Docket No. 50-213

IE Bulletin No. 80-20
Page 1 of 2

FAILURES OF WESTINGHOUSE TYPE W-2 SPRING RETURN TO NEUTRAL CONTROL SWITCHES

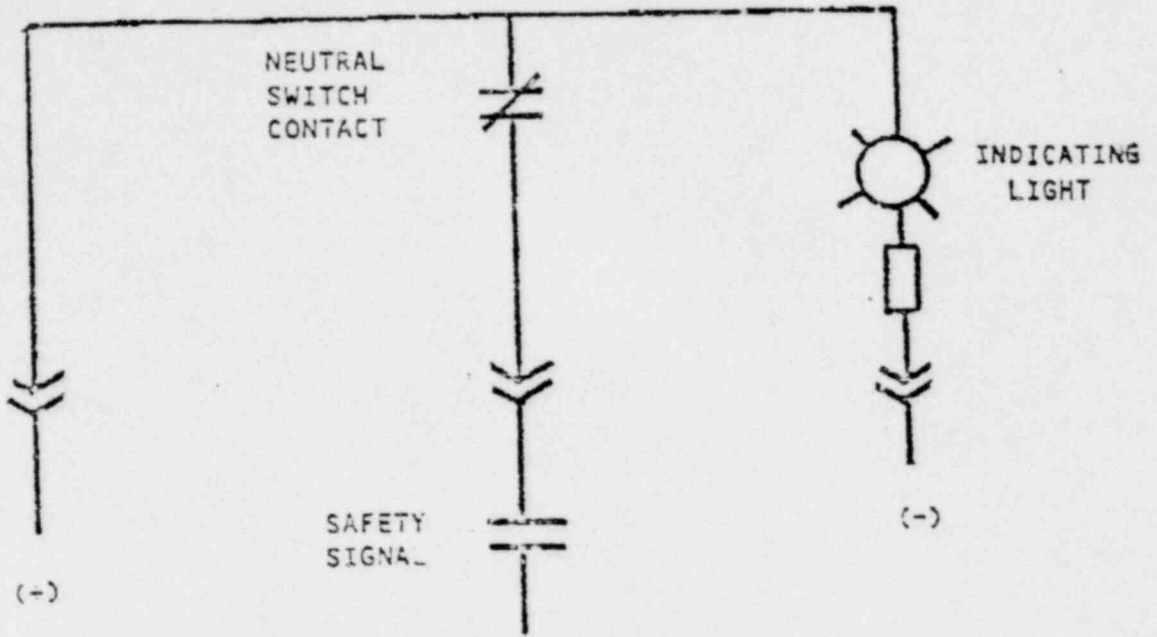
A review of this matter by Westinghouse led to the issuance of NSD Technical Bulletin No. NSD-TB-80-9 to the utility owners of all Westinghouse operating plants. The recommendations contained in the Westinghouse technical bulletin include: (i) testing the neutral position contacts of the subject W-2 switches for continuity, and (ii) rewiring of the indicating light circuit to permit the early detection of a neutral contact failure as shown in Figure 1.

FIGURE 1

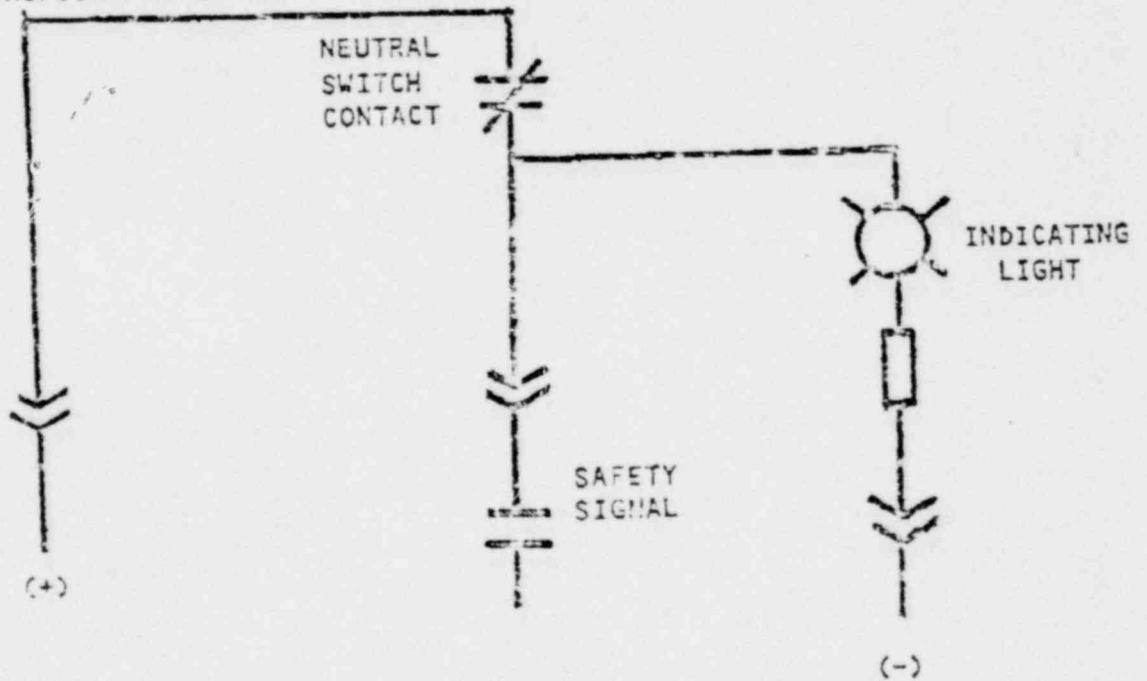
Depending on how the indicating light circuit is wired, loss of continuity thru the neutral position contact of a W-2 switch could remain undetected until the equipment associated with the switch were called upon to operate. Since such a failure would be equivalent to by-passing the system associated with the switch, consideration should be given to rewiring the switches used in safety-related applications as shown in Figure 1. Such rewiring would provide an acceptable means for detecting contact failure, provided the indicating light is in the control room and readily visible by the operator. If the indicating light is not so located, consideration should be given to annunciating the neutral position contact failures at the control room to alert the operator of the inoperable status of a safety-related system. In addition, consideration should be given to adding redundant contacts to the W-2 switches or to replacing the W-2 switches with others having a more positive contact wiping action.

3. Licensees of operating plants and holders of construction permits shall describe the longer term corrective measures planned and the date by which such measures will be implemented by actual installation or by design change, as appropriate. As a minimum, the longer term corrective measures should include rewiring the indicating light as shown in Figure 1 provided the light is readily visible to the control room operator. If not, failures of the neutral position contacts should be annunciated in the control room.

REWIRING OF INDICATING LIGHT CIRCUIT OF W-2 SWITCHES
AS RECOMMENDED BY WESTINGHOUSE TECHNICAL BULLETIN NSD-TB-80-9
